EXHIBIT J (Rev. 1) to Development Agreement
Development Standards and Design Guidelines for
MountainStar Master Planned Resort
March 18, 2008

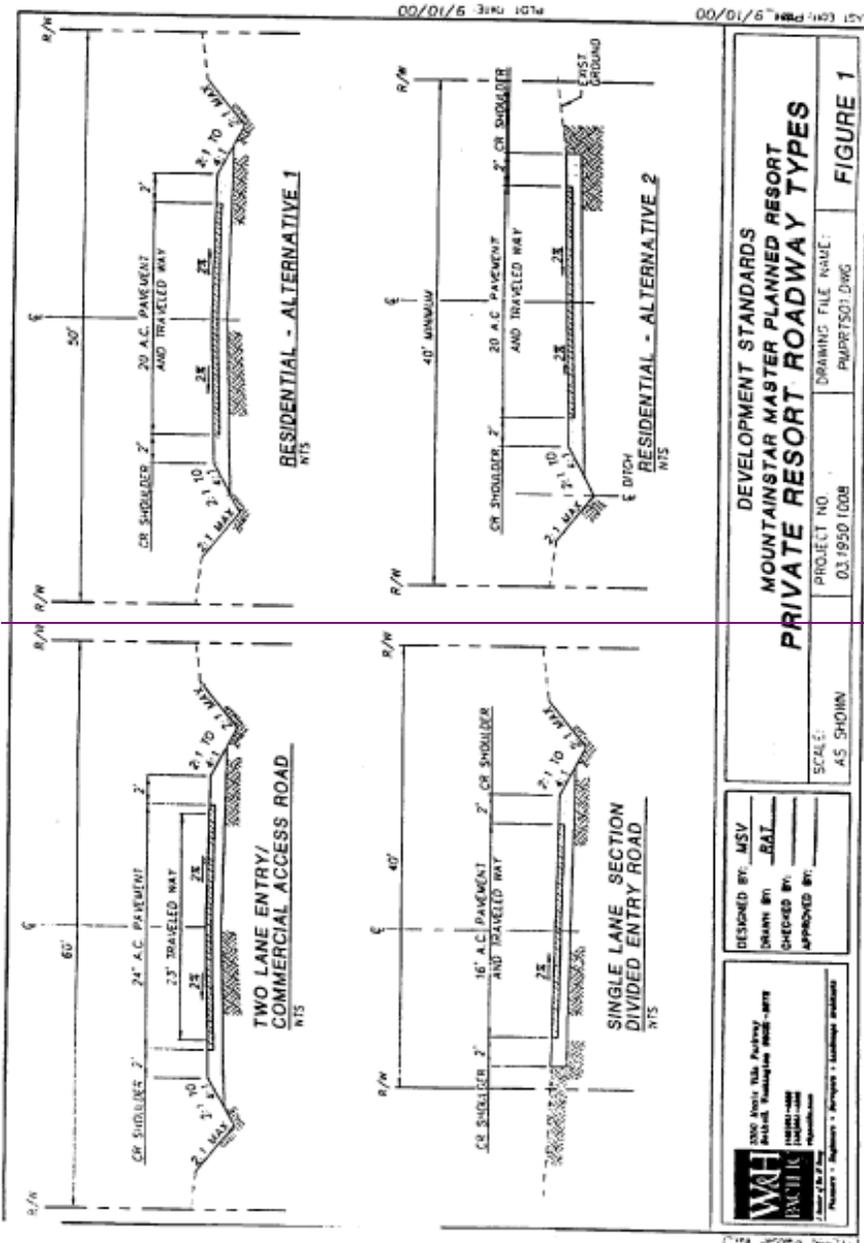
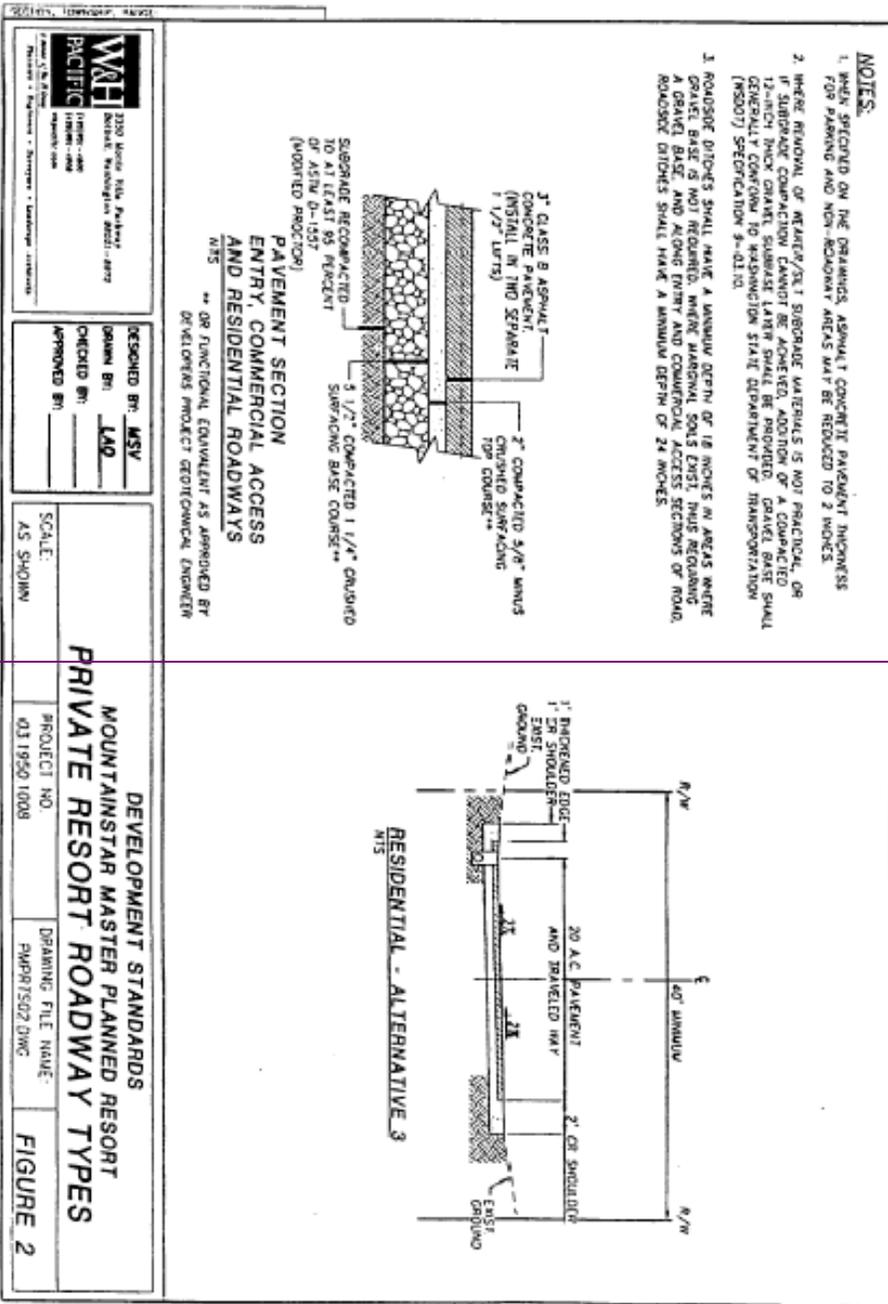
Project Roadway types, except as special conditions may otherwise dictate, shall conform with the types shown in Figures 1 and 2 and Table 1. Selection of alternative residential roadway types shall be by the developer. Pavement sections shall conform with the section shown in Figure 2.

The roadway types shown in Figures 1 and 2 and Table 1 represent modifications from standard road types set forth in KC 12.20.050 of the Applicable Law. The modifications are necessary to achieve the low design speed objectives of the resort, impacts on natural features, and support a safe rural and natural theme.

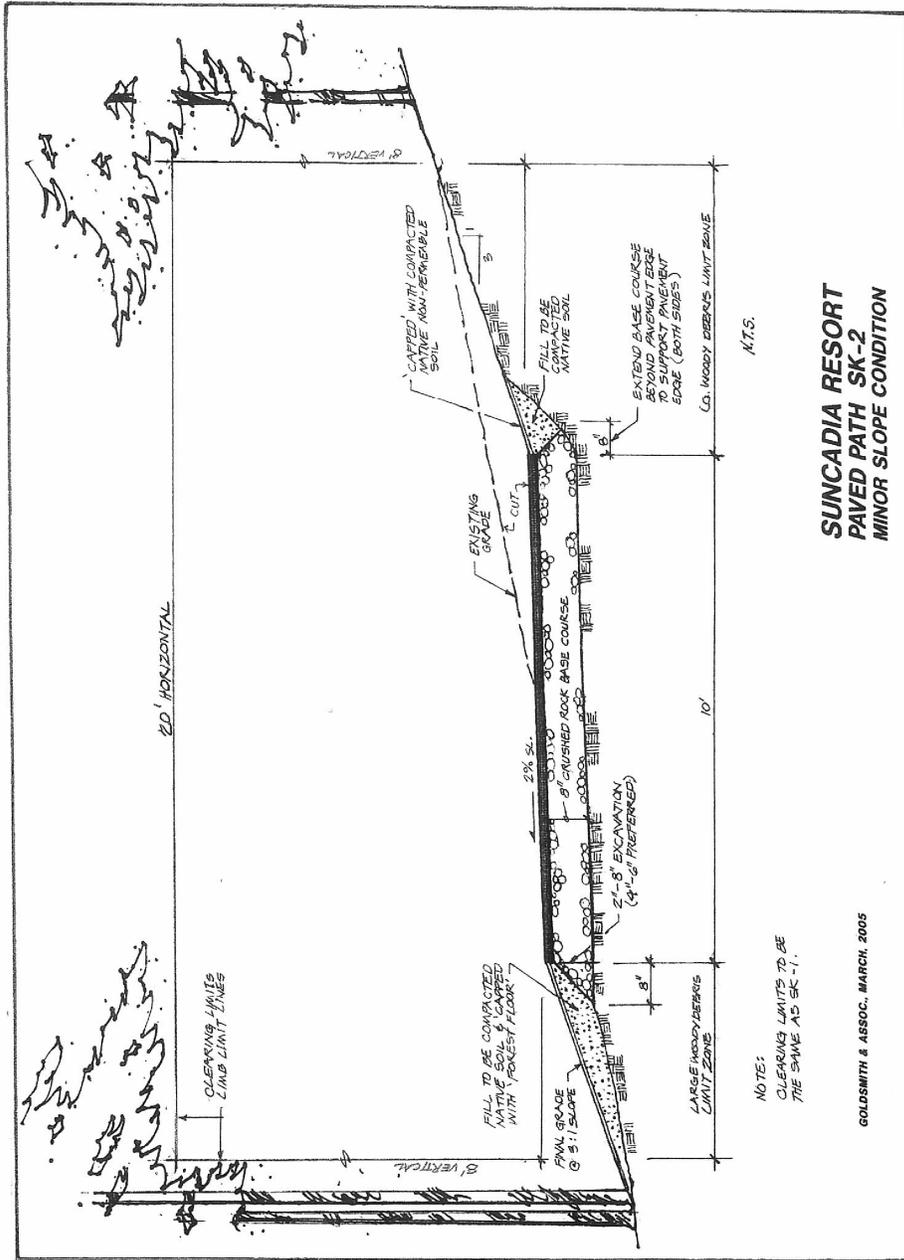
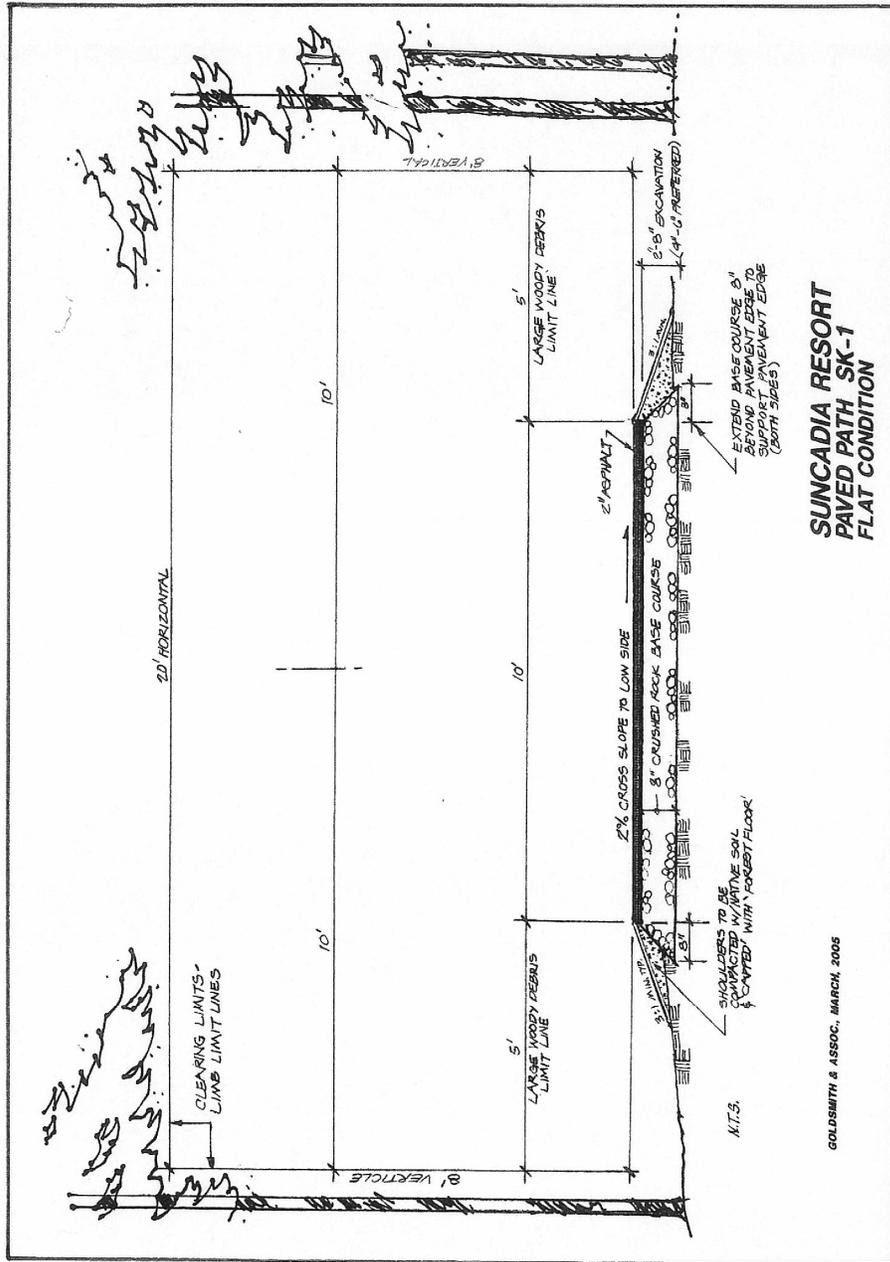
The path types shown in Figures SK-1 and SK-2 and Table 2 represent path design necessary to achieve design objectives of the resort which minimize impacts on natural features and support a safe rural and natural theme.
